PLANT NAME:
Nine Mile Point Unit 1
VT 8/2/77

Consists of requested additional information regarding the spent fuel pool modification for Unit 1.

Re: Nine Mile Point Unit 1
Docket No. 50-220
DPR-63

Responses to June 30, 1977

BASE AND
RESTRAINT
ARRANGEMENT
GROUP 1 (NORTH)
RACK SET

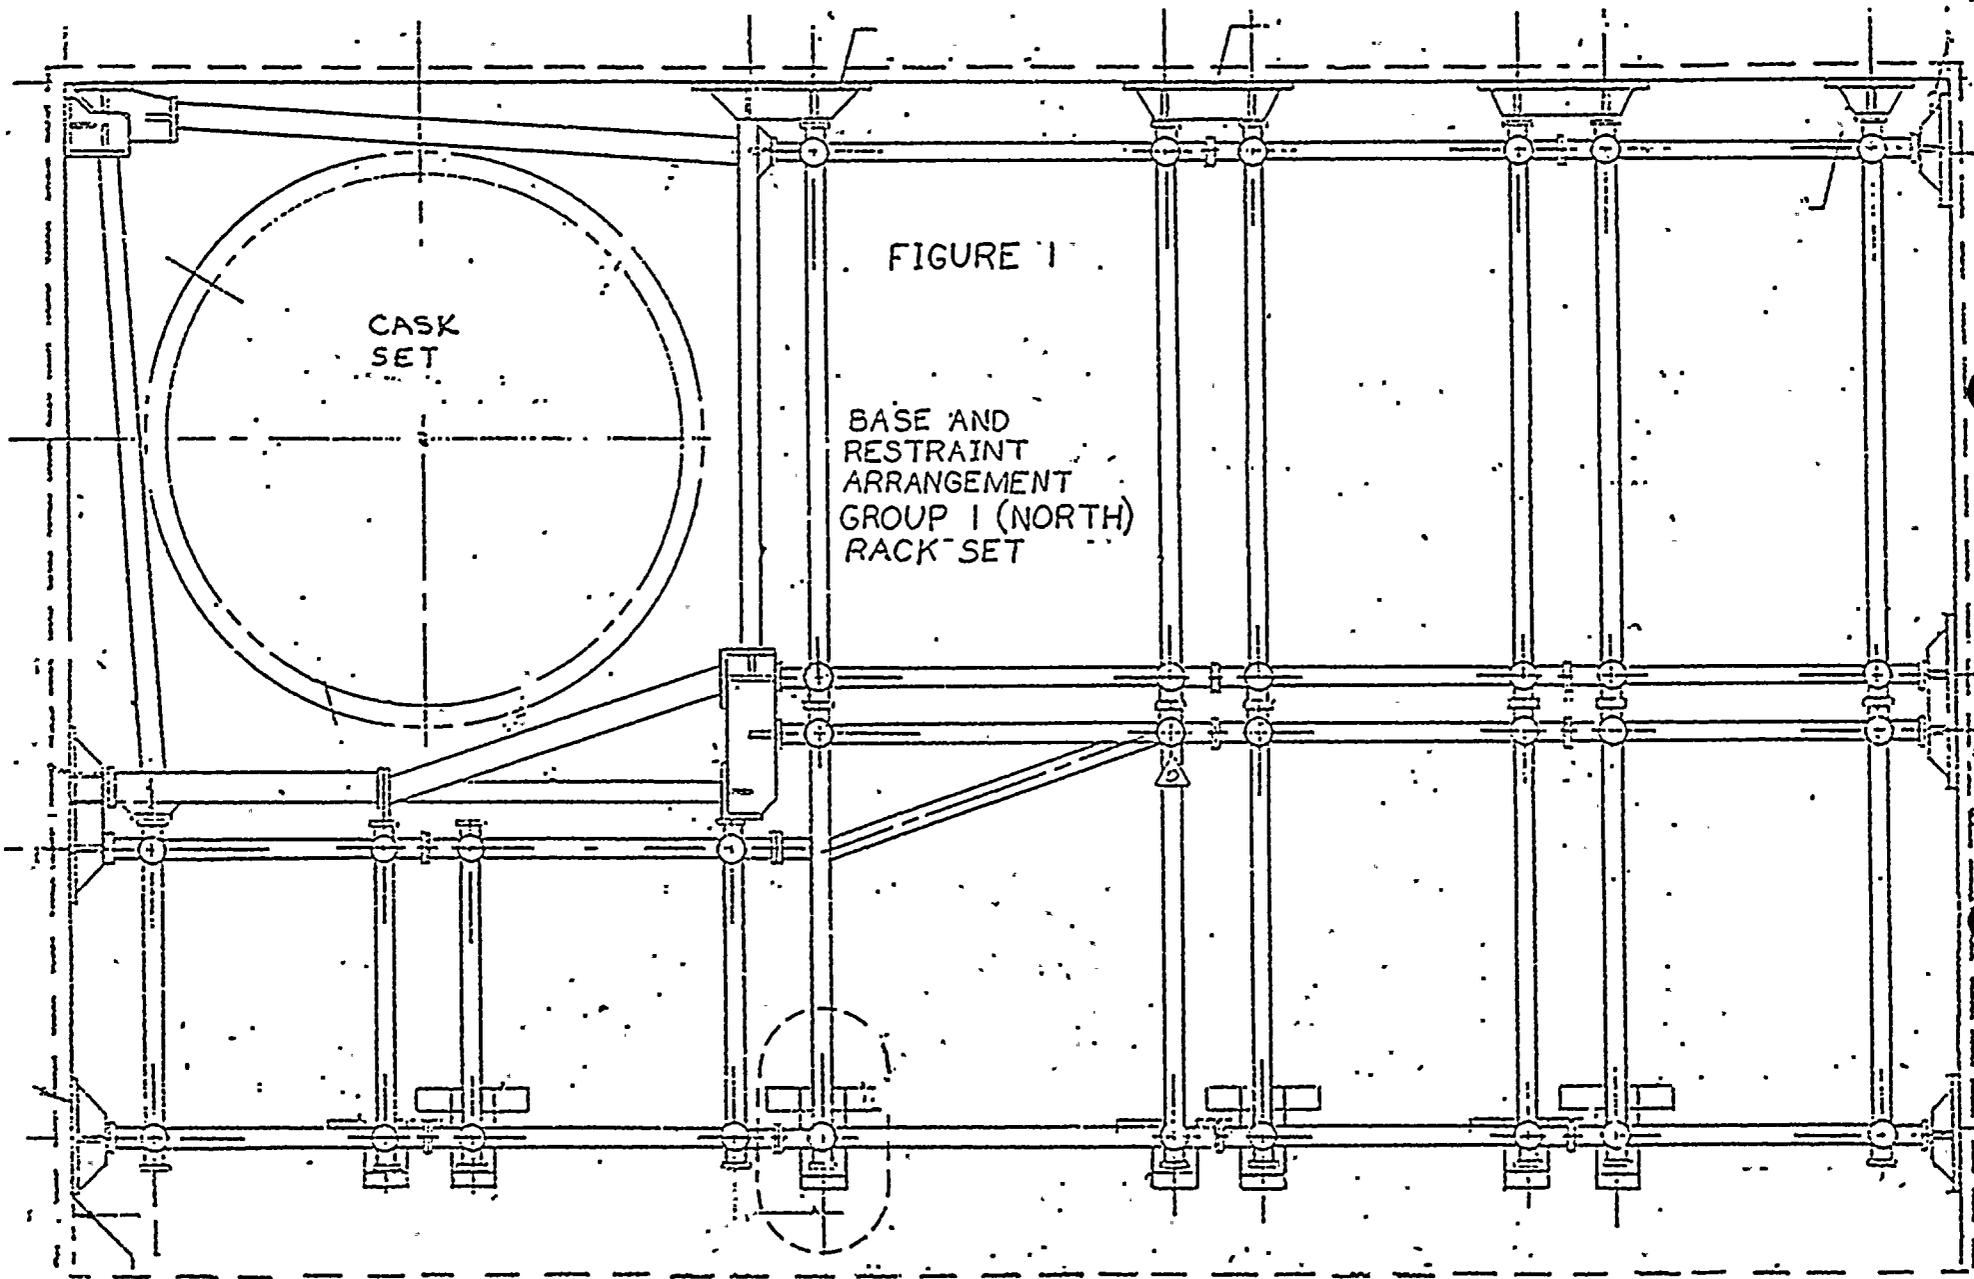
1. Provide a summary of the stresses and safety margins in the diagonal braces across the bottom of the refueling canal, the shear blocks and the snubbers, and the bearing stresses and safety margins where the snubbers contact the fuel pool walls. In addition, figures 1.3 through 1.5 of the February 11, 1977, response to NRC question 1 indicate that the shear blocks, diagonal braces, and snubbers are not physically connected to the rack base legs. This may be unacceptable since friction should not be relied upon to fasten these components under a seismic event. Also, consider the possibility of lateral instability of the diagonal braces affecting their load carrying capacity.

The current design of the seismic bases eliminates shear blocks and relies on rack base to rack base "bumpers" that are part of these bases. The arrangement for the Group 1 (North) rack sets and cask area seismic supports are shown in Figure 1. The arrangement for the Group 2 (South) rack sets is shown in Figure 2. Seismic restraint in the southern direction for Group 1 racks is by means of bumpers that are attached to the bases and bear against the mounting brackets imbedded in the pool floor. Similar supports restrain the Group 2 racks in the northern direction. Figure 3 shows the detail of this support. The wall support is depicted in Figure 4. A summary of stresses are:

The minimum margin of safety among rack base structures occurs in the East-West members of the base in the Southeast corner of Group 1 racks. The margin of safety is 0.40 of the Operational Basis Earthquake stress-limit. The corresponding compressive stress is 14 KSI.

The minimum margin of safety among members forming the cask area restraint is in the East-West column running along the north wall. The margin of safety is 0.09 of the Safe Shutdown Earthquake buckling limit.
